State Significant Development 10404

Horsley Drive Business Park Stage 2 –
Building 1

Section 4.55(1A) Modification Application
(Mod No. 1)

Figure 10 Proposed Elevations (South and West) – SSD-10404-Mod-1

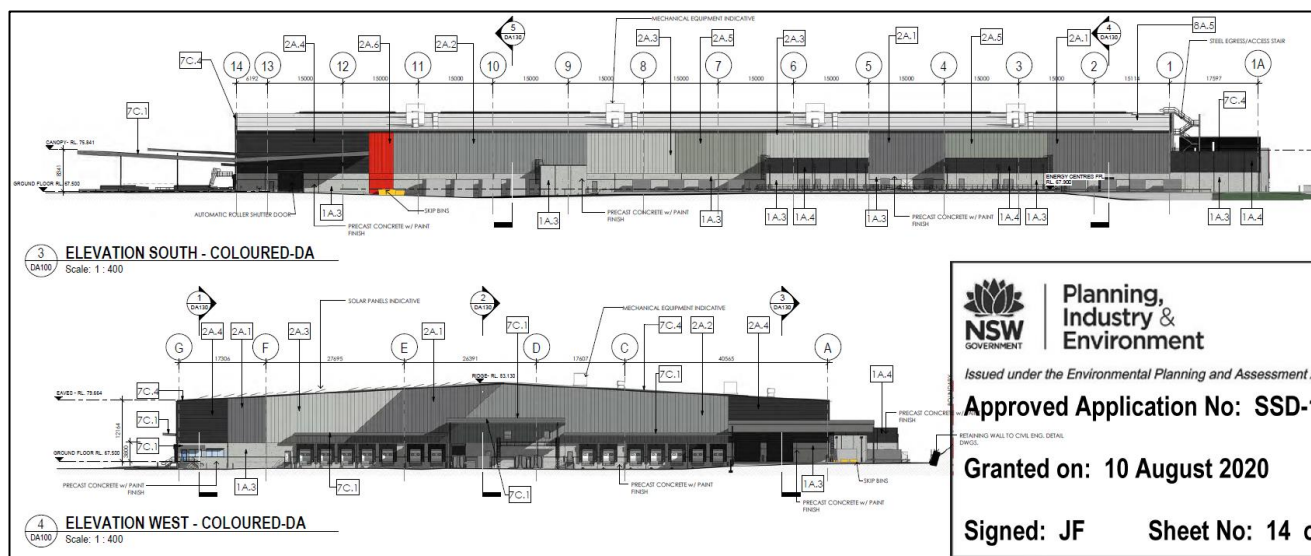
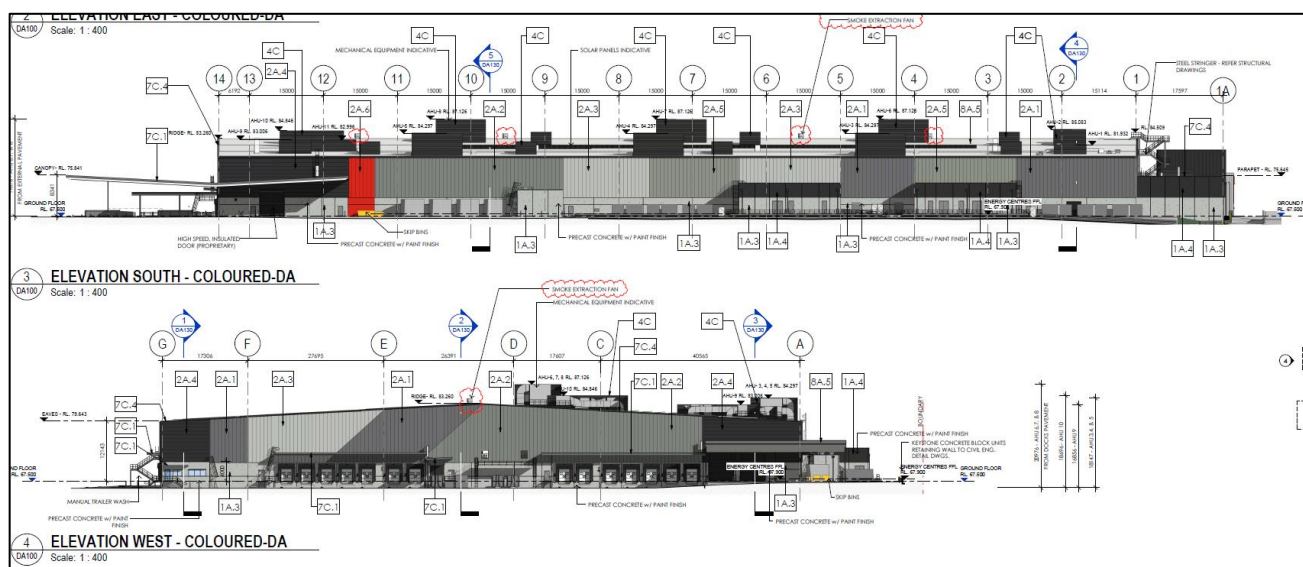
Mechanical engineers have advised that the plant equipment and condensers cannot be located within the building or at ground level and must be placed on the roof for optimal operation and maintenance. This results in the overall height of the building exceeding the maximum building height of 16 metres.

The approved elevation for Building 1 (SSD-10404) is shown in **Figure 9** and the proposed modification to the Building 1 elevation to incorporate a 20m height limit is shown in **Figure 10** below. A complete set of amended Architecture Plans in **Appendix A** illustrate the scope of proposed changes to the site layout and built form.

Figure 12 Proposed Overall Site Plan (DA020, Rev K)

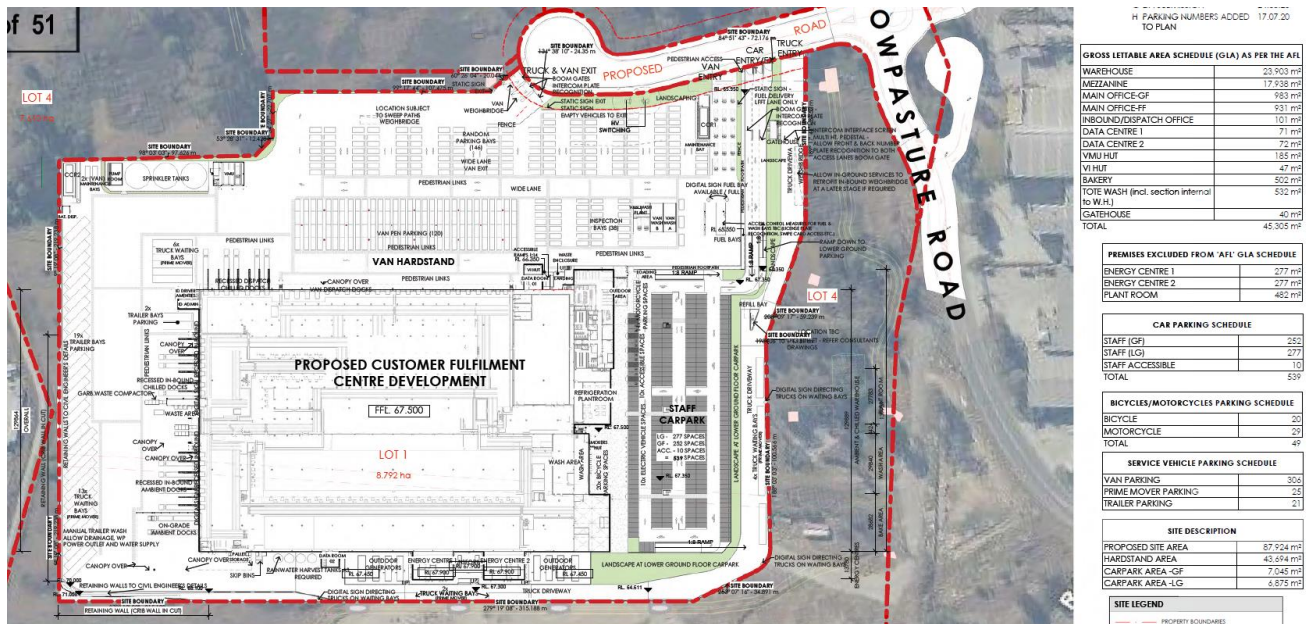
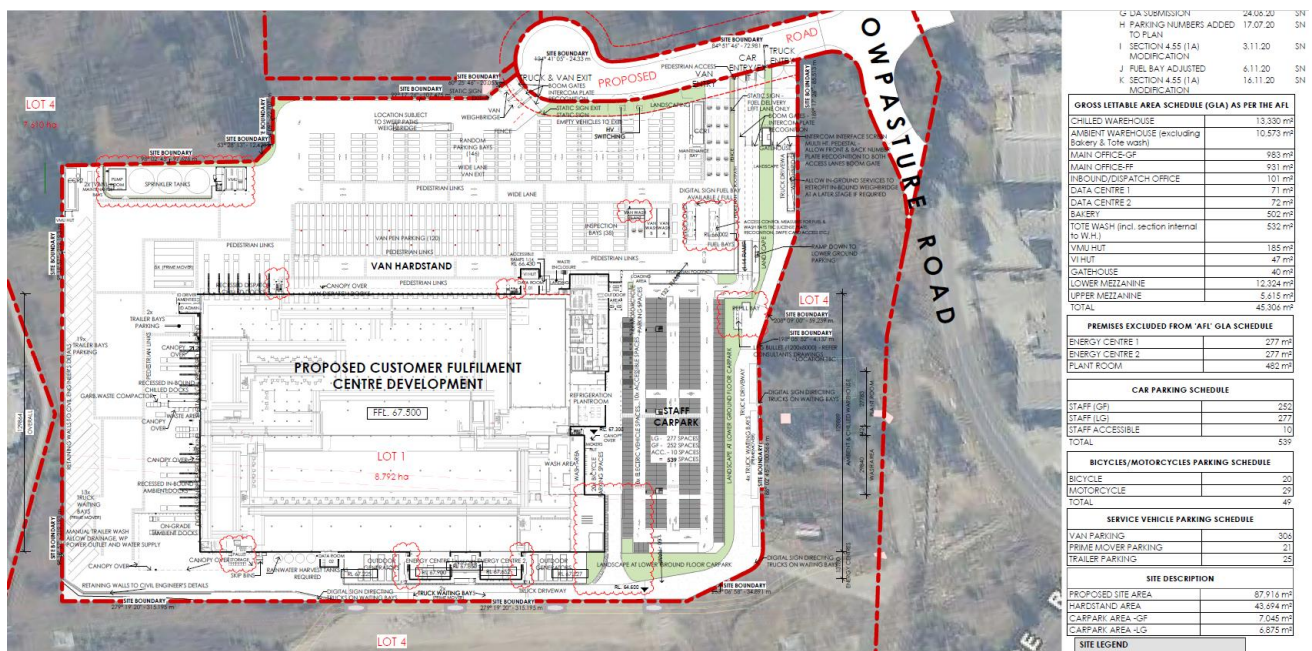
- Identification of rooftop mechanical plant equipment on the building
- Rooftop mechanical plant platforms with screening treatments
- A new service driveway added from the southern truck driveway to access the plantroom
- Stairs added to the north façade for reduced egress distances
- Additional mezzanine and walkways to facilitate egress
- Reconfiguration of fuel bays to include a second fuel bay
- Increase to the side of the Fire Pump Room and shifting sprinkler tanks to the east slightly
- Plant room façade height extension
- Additional signage zones

Figure 11 and Figure 12 shows a comparison of the approved site plan and proposed site plan, highlighting the proposed amendments.
